Subject: **Bid No. 8800-M7 – Accessibility Renovations – New Citizen Center / WPS**

ADDENDUM NO. 3

**1407A MAIN STREET
WORCESTER, MA 01603**

HABEEB & ASSOCIATES
ARCHITECTS

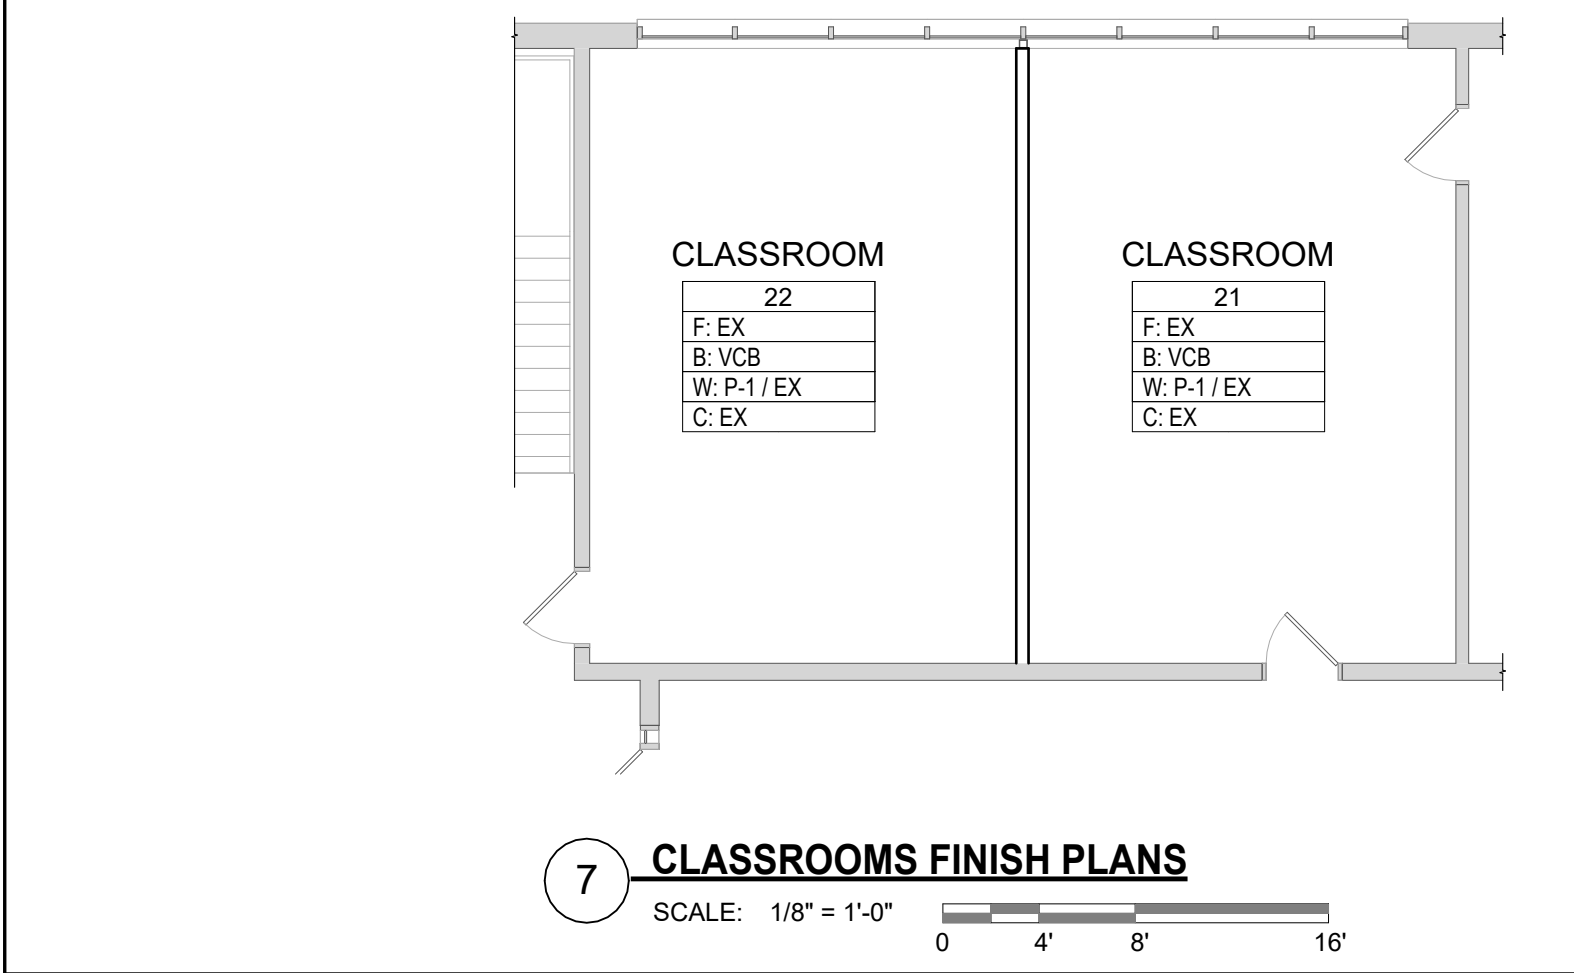
Answer:	Will be answered in future Addendum
Question:	clarify whether Rooms 12 and 12A receive the vinyl base shown on A-710 or the specified 6-inch integral resinous base.

Answer:	Rooms 12 and 12A to receive integral epoxy cove base.
From:	Poulin Construction
Question:	Need clarification on Adult changing station, make and model perhaps Also same question for the shower seat, make and model

E000

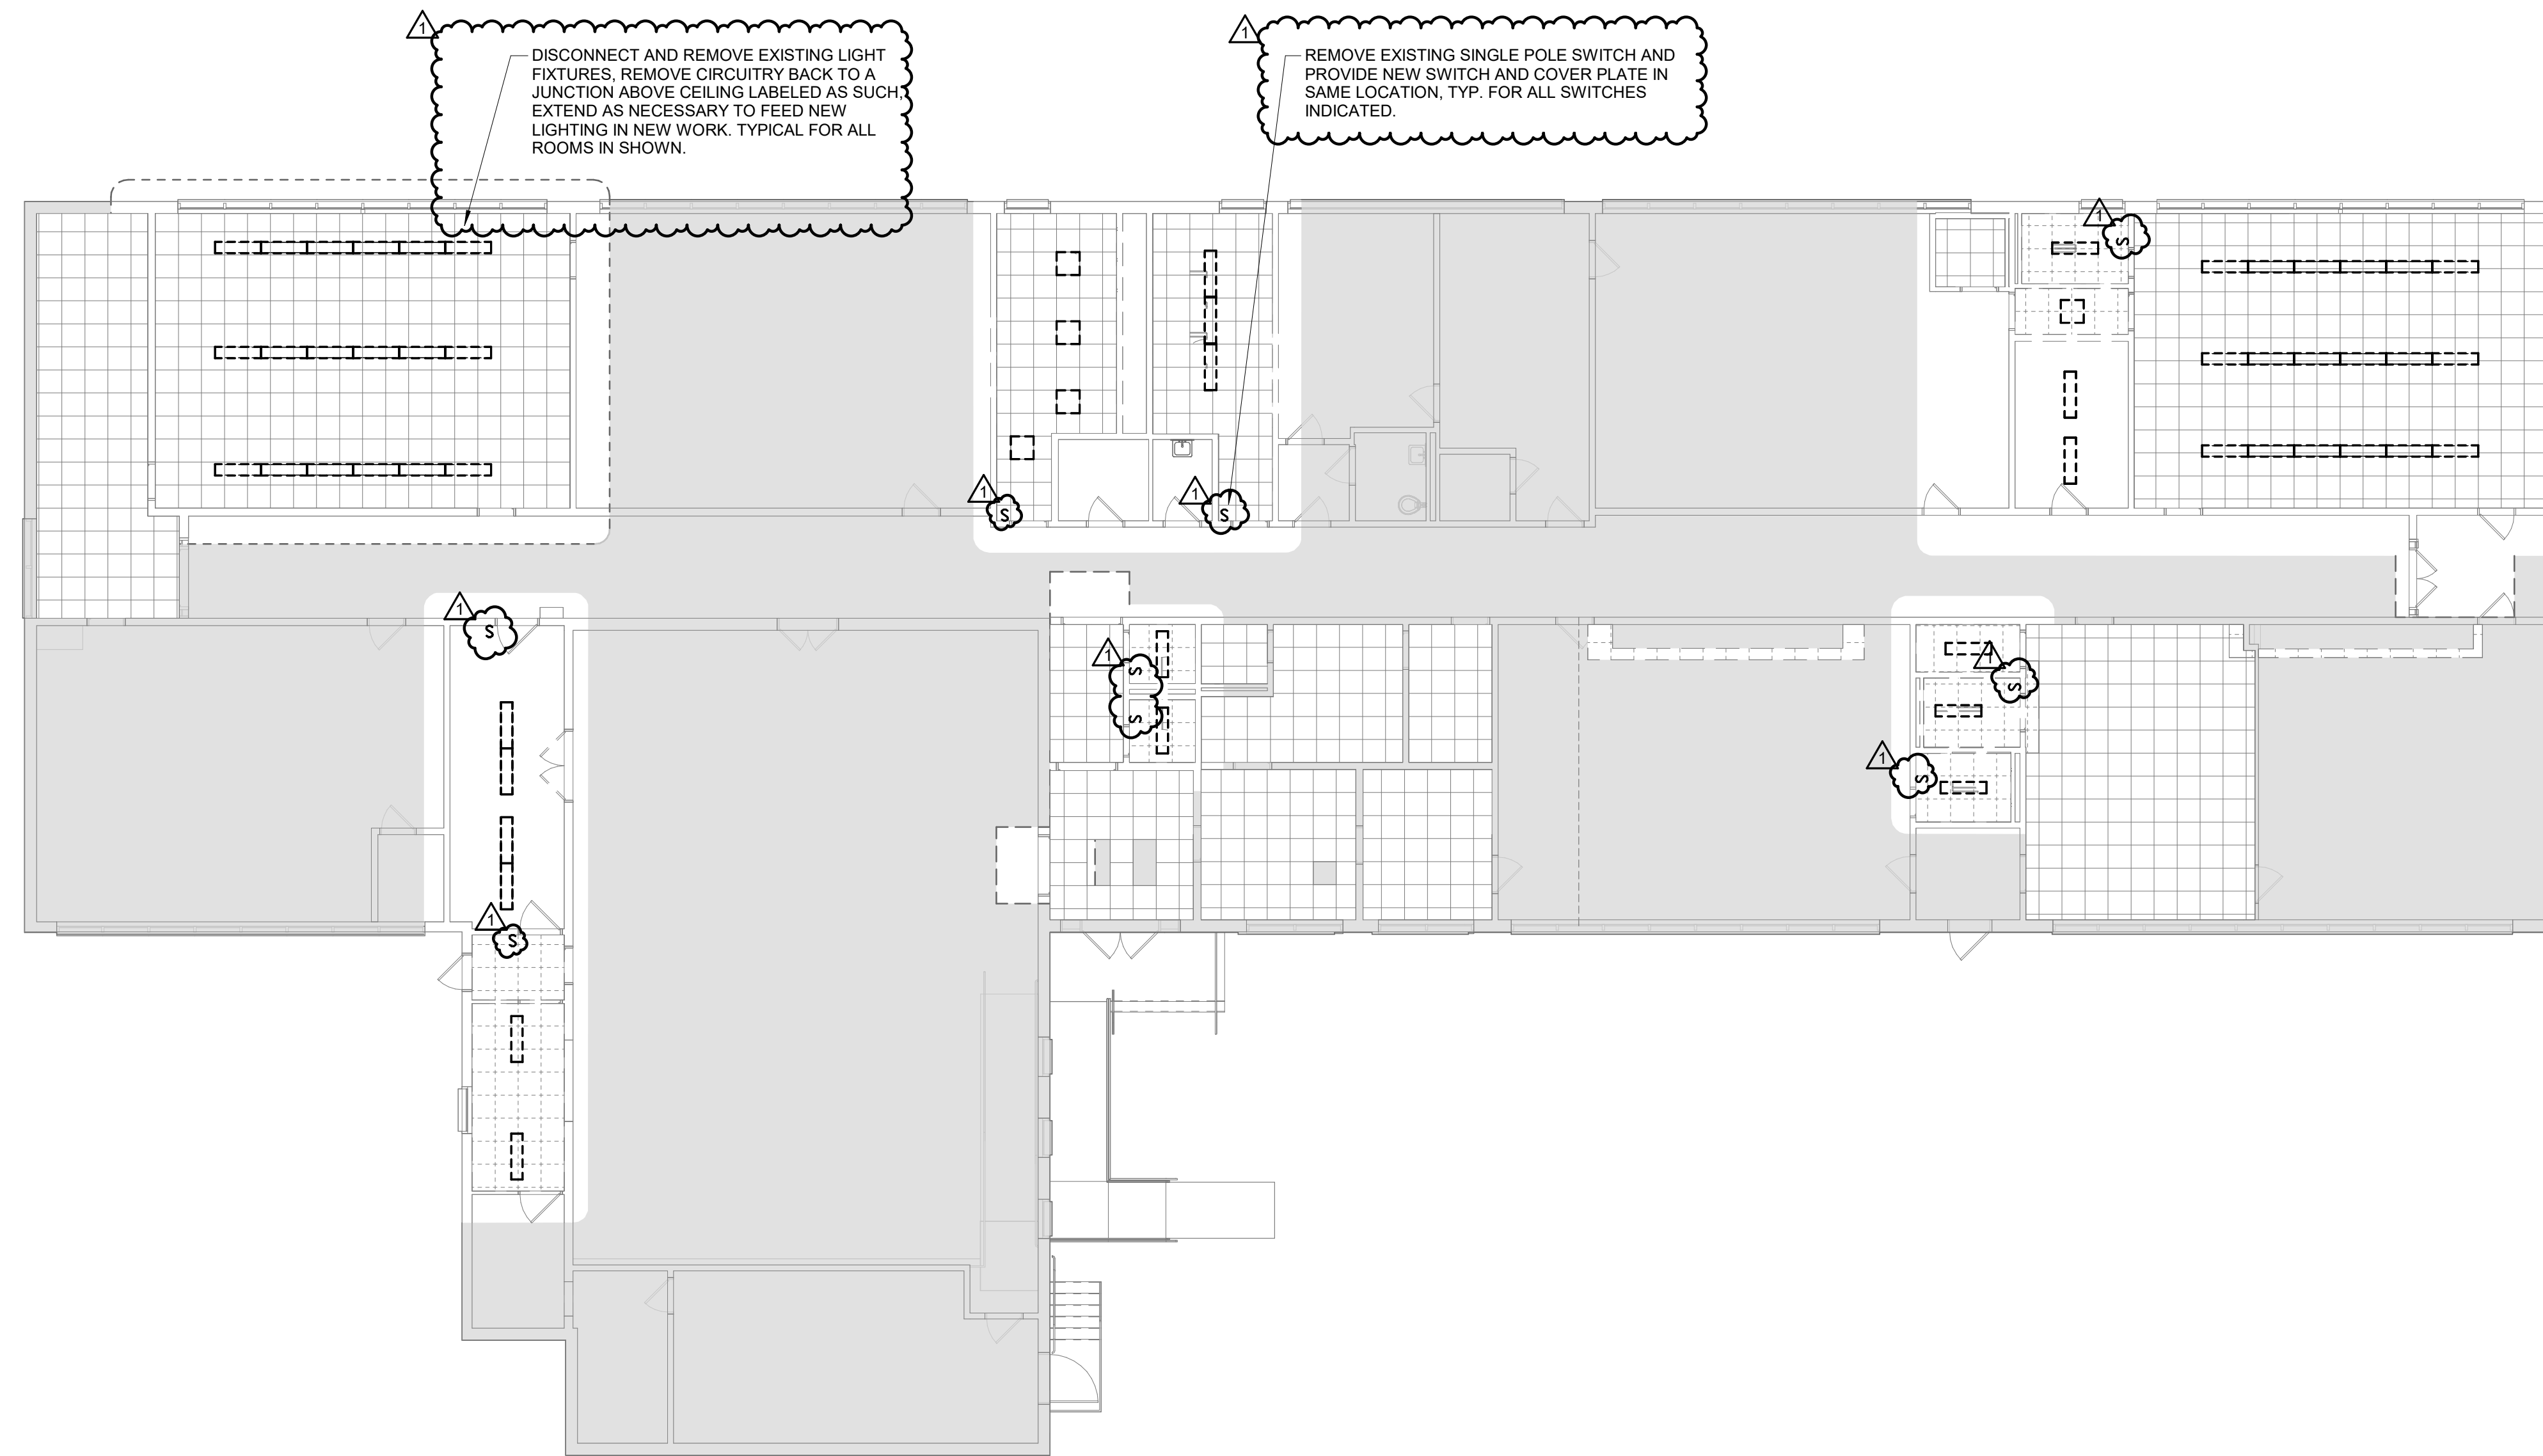
E000	Added fire alarm legend, wiring notes and fixture disposal notes.
E101	Added notes related to demolition of fixtures, circuiting and switches.
E210	Added locations for fire alarm control panel and main panel. Added notes to clarify scope on panel replacement, fire alarm control panel scope and generator replacement.
E300	Added notes related to demolition of fixtures, circuiting and switches. Added fixture tags and notes related to recircuiting.
E301	Added fixture tags and notes related to recircuiting.
E302	Added circuiting to receptacles and split systems.
E303	Clarified locations for fire alarm horn/strobes and fire alarm strobes. Revised smoke detector/carbon monoxide layout.
E600	Added panel schedules and revised fixture schedule to provide description of fixtures.

Answer:	Addendum 3 has clarified disposal requirements for the existing fixtures on sheet E000.										
From:	MV Electrical										
Question:	Drawings E300 & E301: Please provide fixture type designations beside fixture symbols on drawings E300 & E301.										
Answer:	Addendum 3 has added fixture types on sheets E300 and E301.										
Question:	Drawing E-210 – Keynote 1 1.) Please provide a site electrical drawing for the new proposed electrical service. 2.) Please provide a power one-line riser diagram. 3.) Please provide a panel schedule for the new "MDP" and load centers to be furnished & installed. 4.) Please provide specifications for the new Generator to be furnished & installed.										
Answer:	Addendum 3 has clarified the scope related to the existing panel and generator on sheet E210.										
Question:	Paragraph-E Listings: Please confirm the following paragraph-e listings do not pertain to this project and shall not be listed on the EC's bid form.

Answer:	This does not pertain to EC
From:	Universal Electric
Question:	There is a specification section referenced in the Electrical Symbol List-Fire Alarm located on drawing E000, but the section is not included with the bid documents. There are no notes on the Systems drawings that refer to the fire alarm system. Please provide Fire alarm system manufacturer and model so we will be able to provide fire alarm devices that are compatible with the existing system.

Answer:	Addendum 3 has provided a fire alarm Legend on E000 and identified the existing system as a Simplex system. All equipment will be by Simplex. This has been indicated on E210 the scope related to the existing panel and generator on sheet E210.
